AGENDA
CITY OF KENTWOOD PLANNING COMMISSION
TUESDAY, JULY 12, 2022
KENTWOOD COMMISSION CHAMBERS
4900 BRETON AVENUE
7:00 P.M.

Case#16-22 - Kum & Go Major Change to the PUD located at 1570 52nd Street, 5215 Kalamazoo and 5249 Kalamazoo

Case #17-22 - Kum Special Land Use and Site Plan Review for a gas station located at 1570 52nd Street, 5215 Kalamazoo and 5249 Kalamazoo

PROJECT: Kum and Go Major Change to an Approved PUD Site Plan

HEET NUMBER:
03

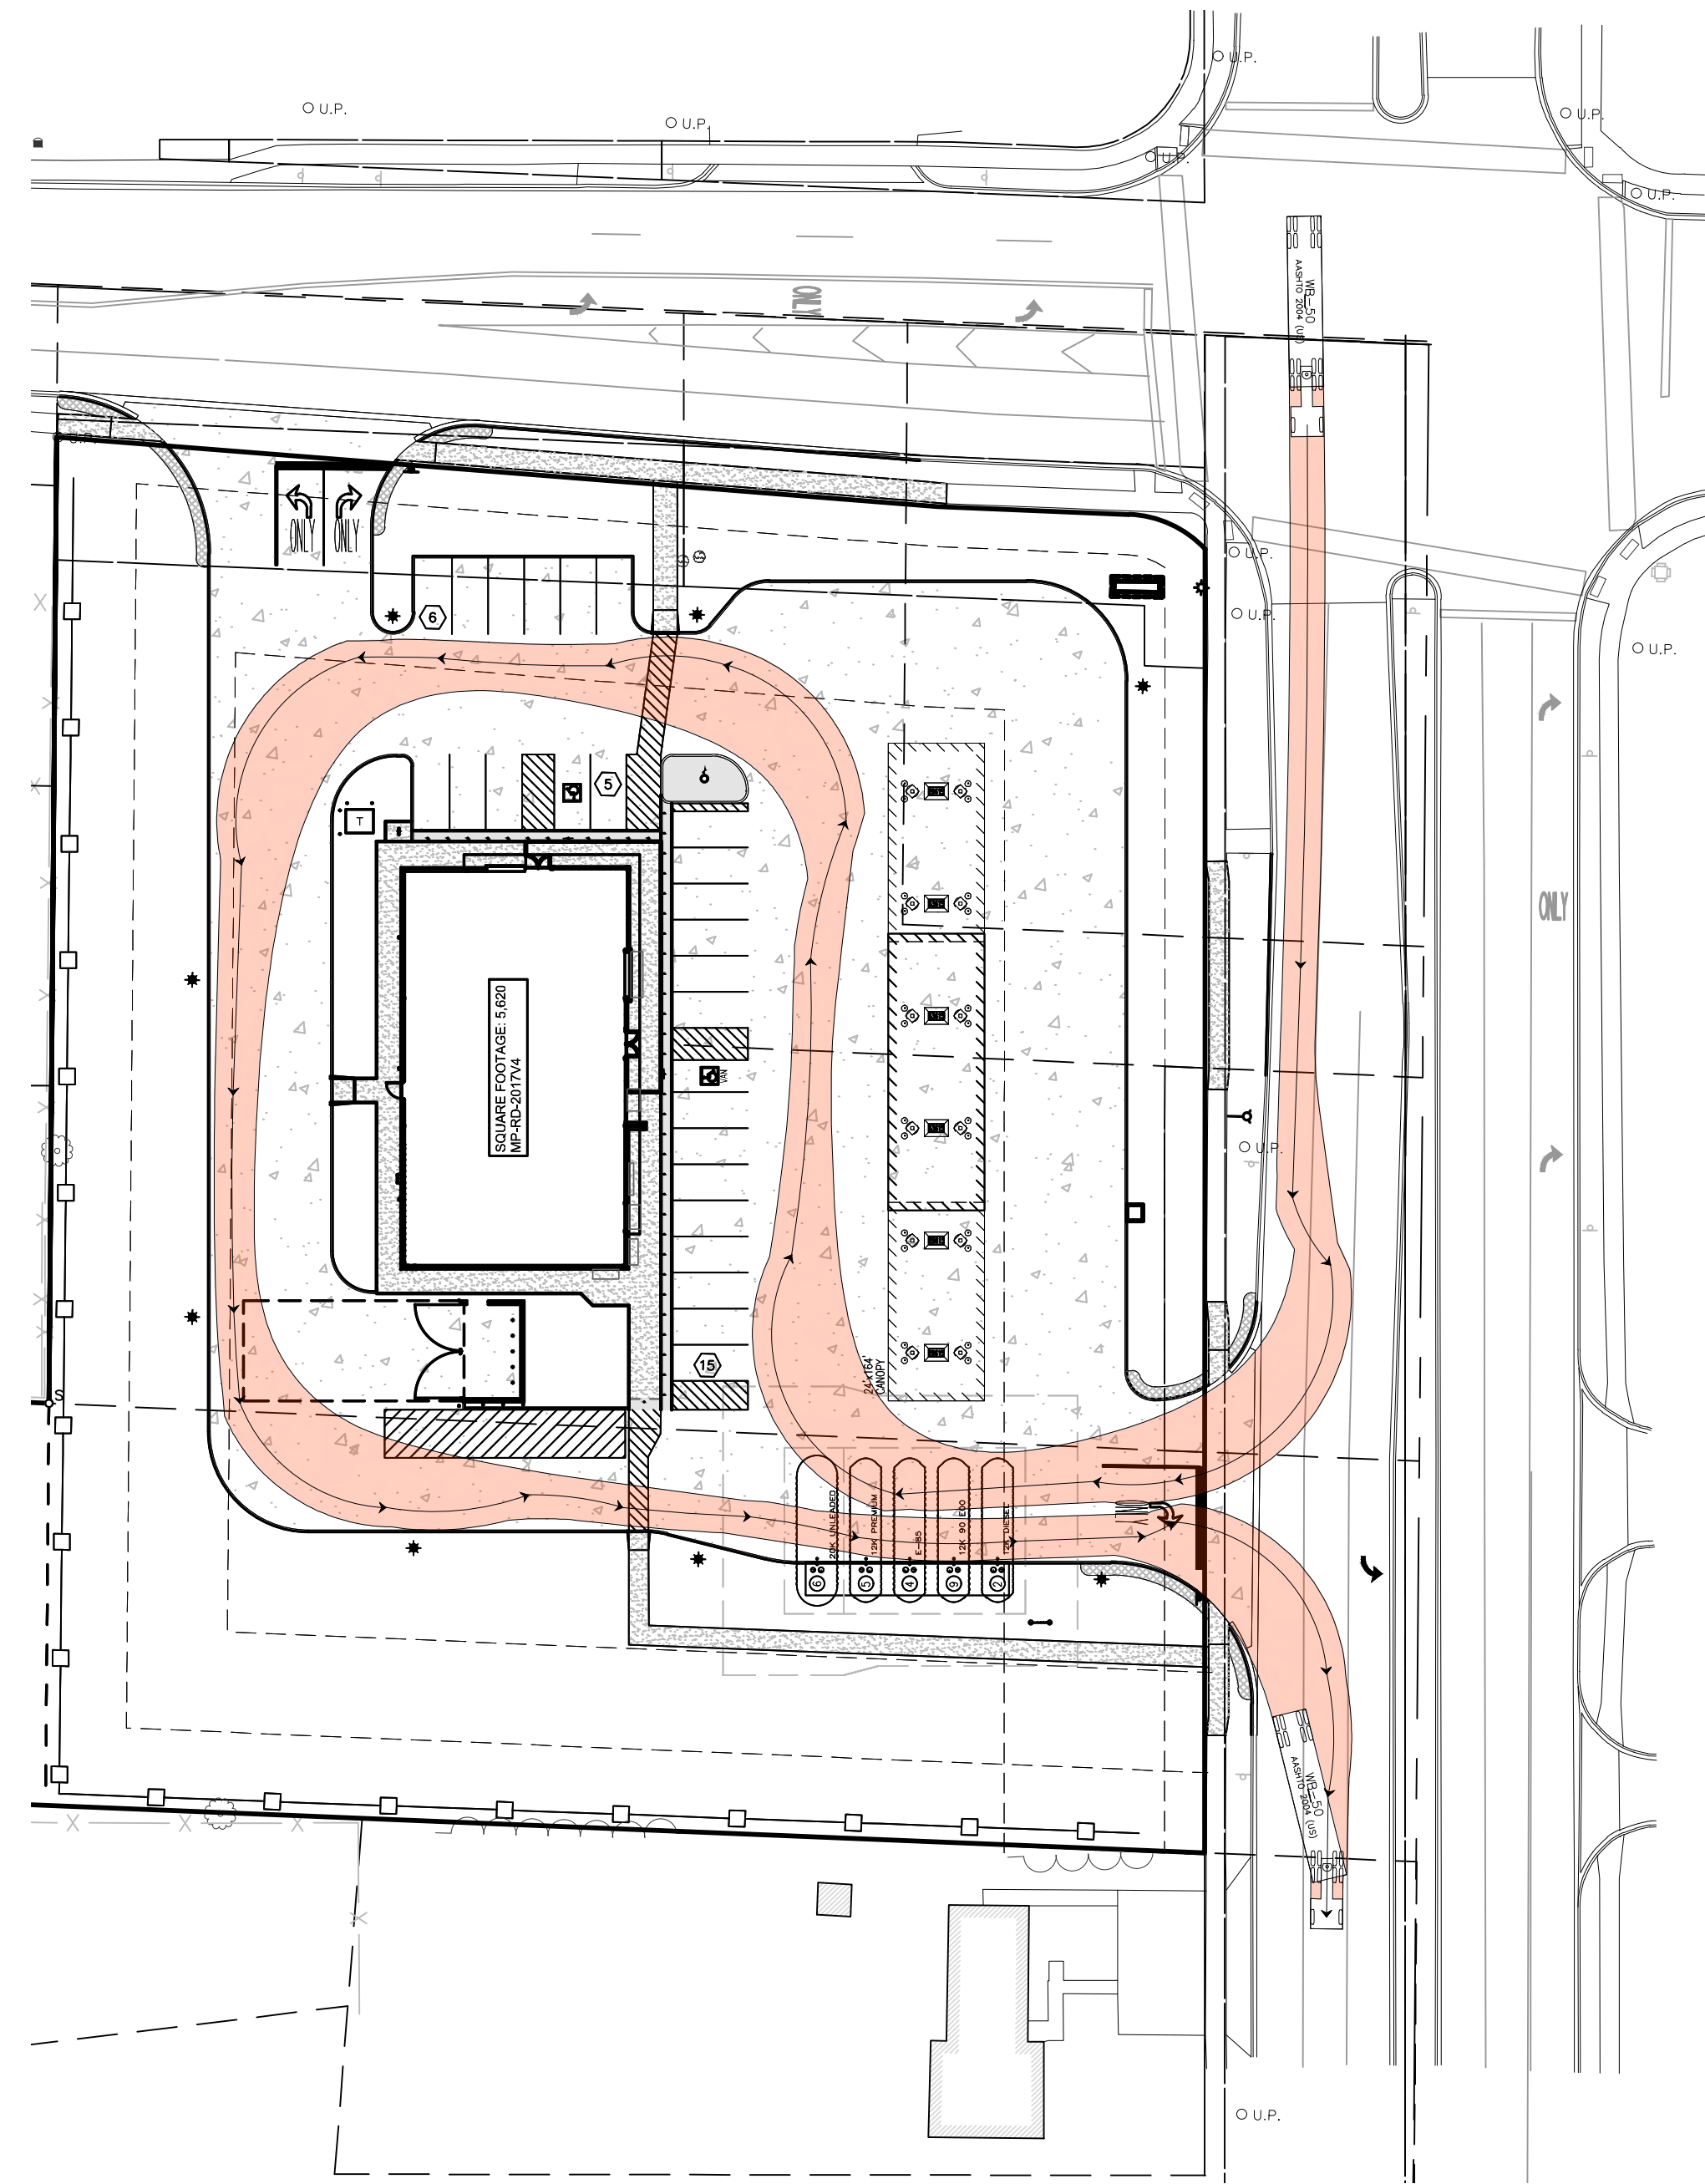
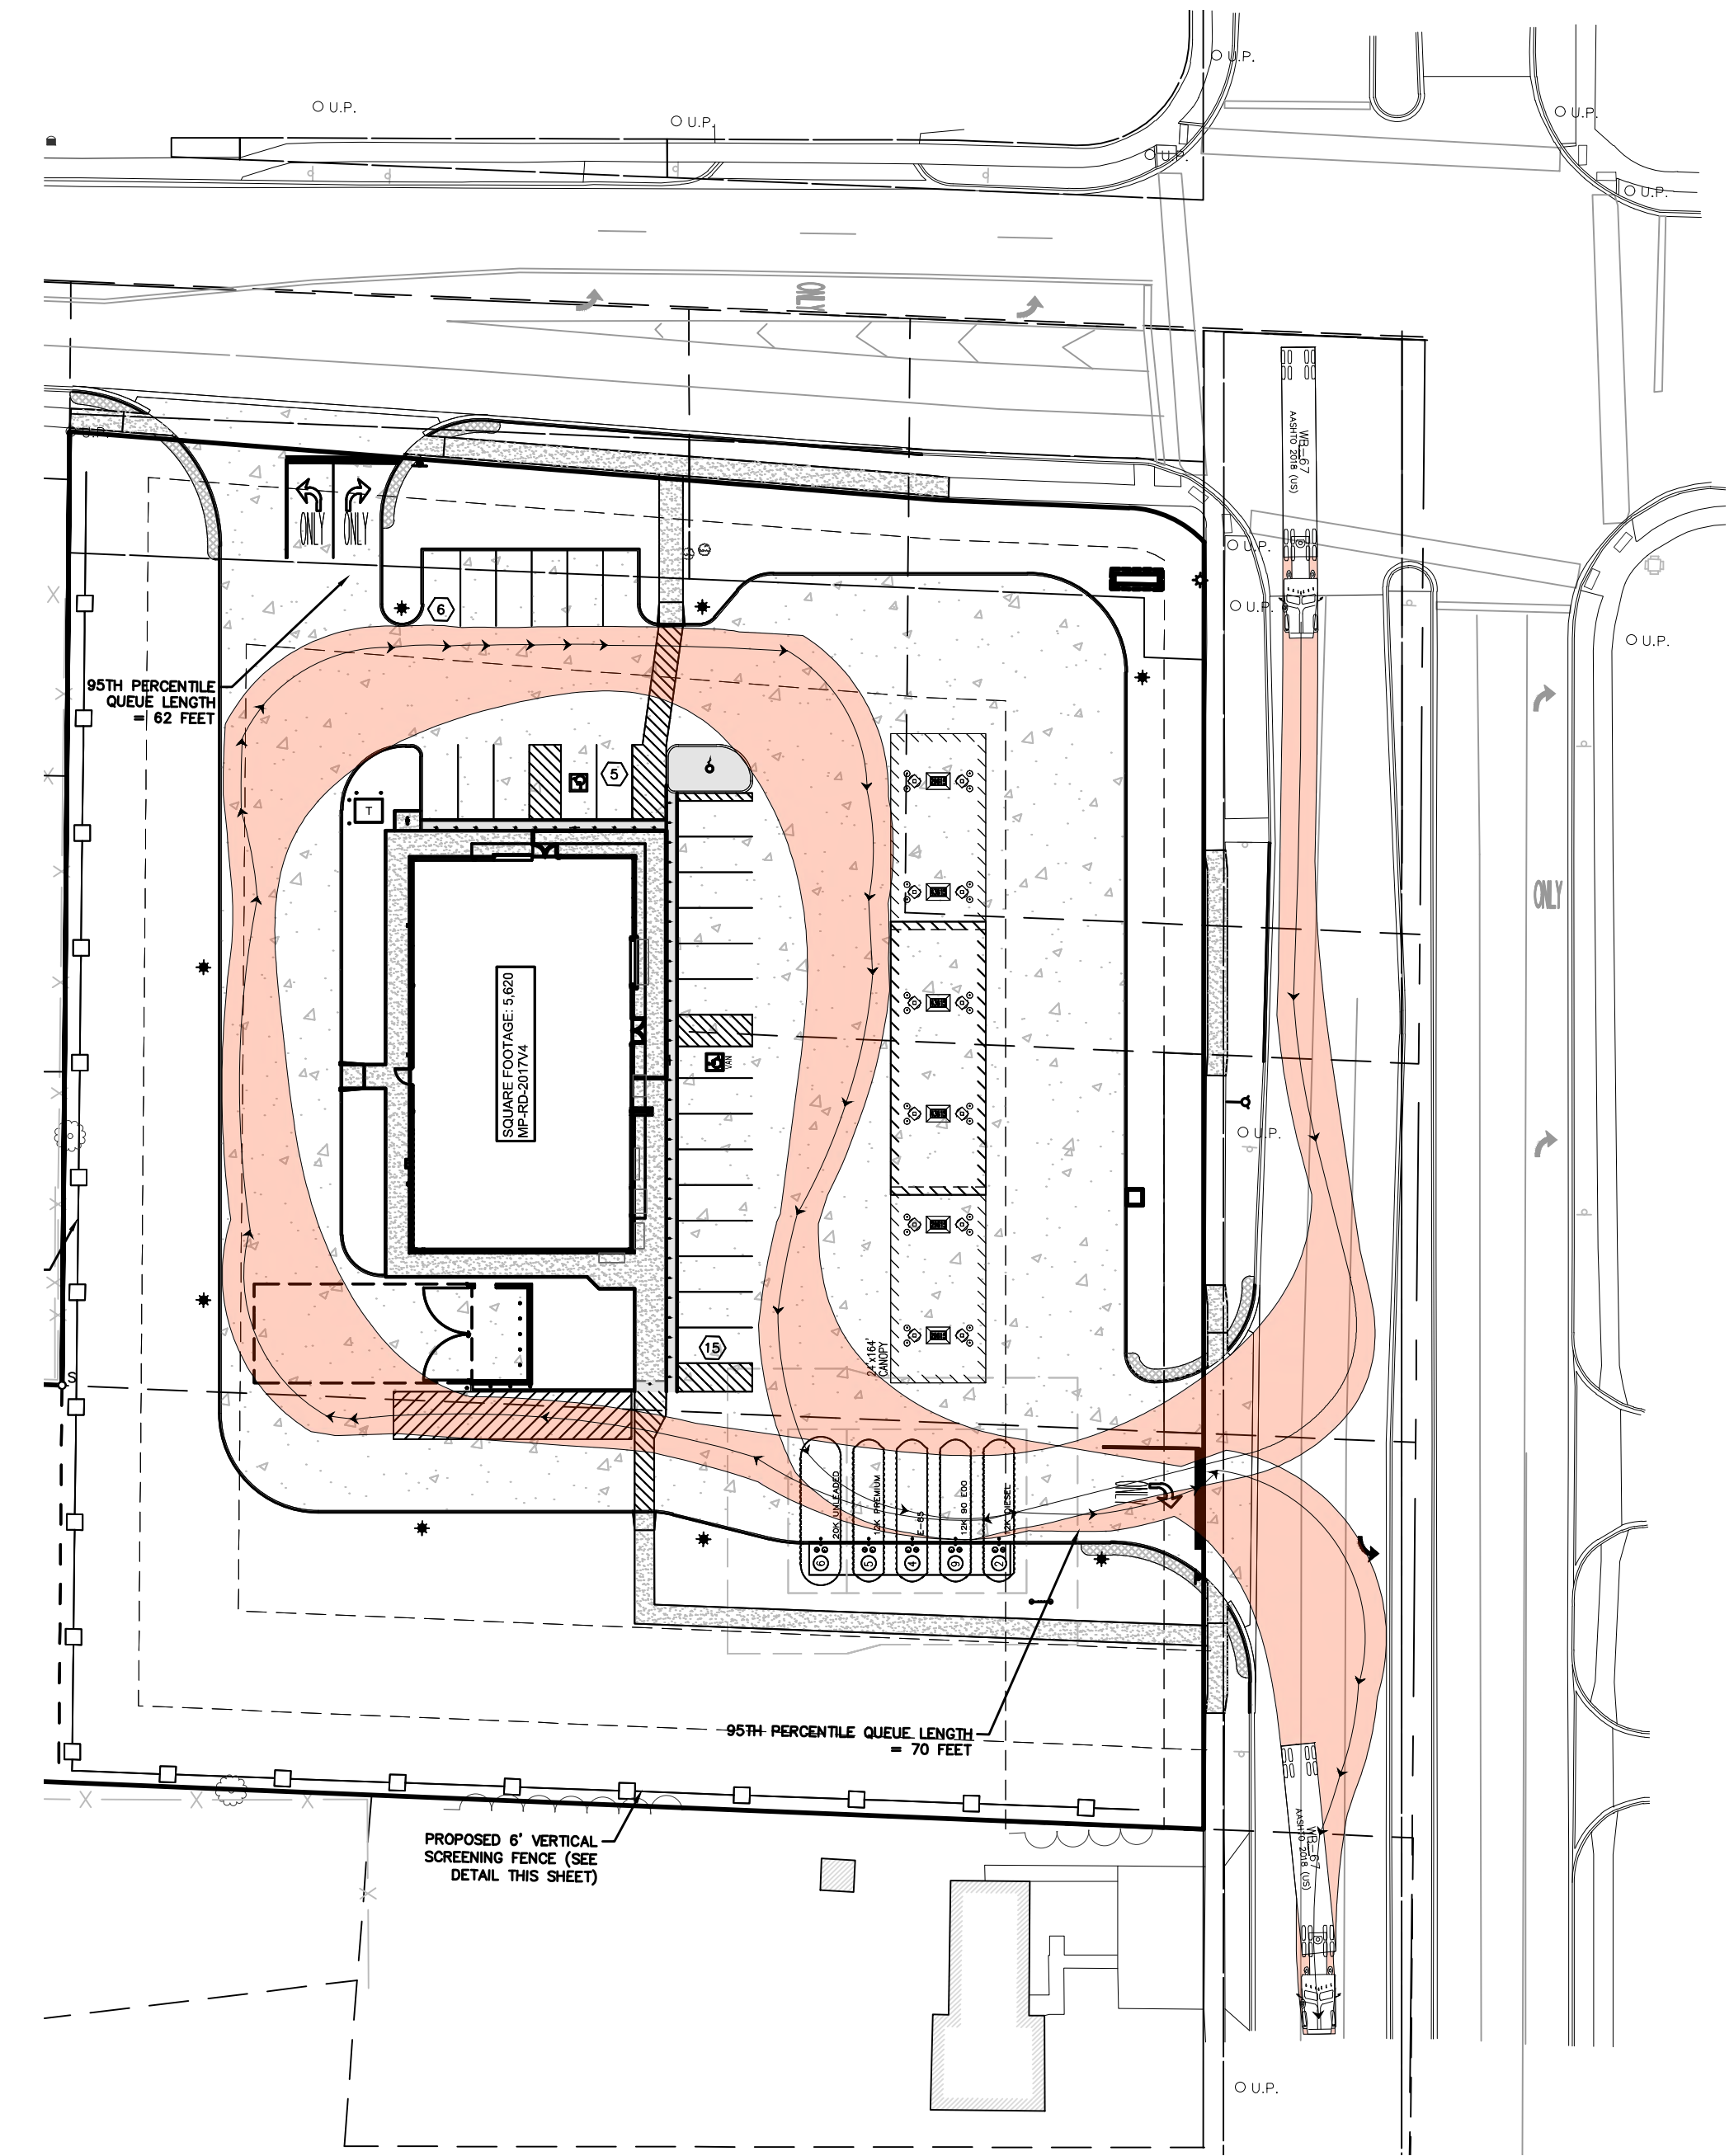
- **The detail for the fence has been updated to a board-on-board style fence. Please refer to sheet 02.**
- **TRUCK CIRCULATION**
 - As noted in the staff review, trucks are to enter and exit from Kalamazoo and an exhibit is required to demonstrate truck routing.

- **A truck circulation exhibit has been added to the site plan set. Please refer to sheet 03.**
- **TRAFFIC**
 - Separate TIS comments were received by the City traffic consultant (SDA) via email. The K&G traffic consultant (F&V) has subsequently provided responses to SDA along with more information. SDA has reviewed the responses and acknowledged that all of their comments have addressed satisfactorily.
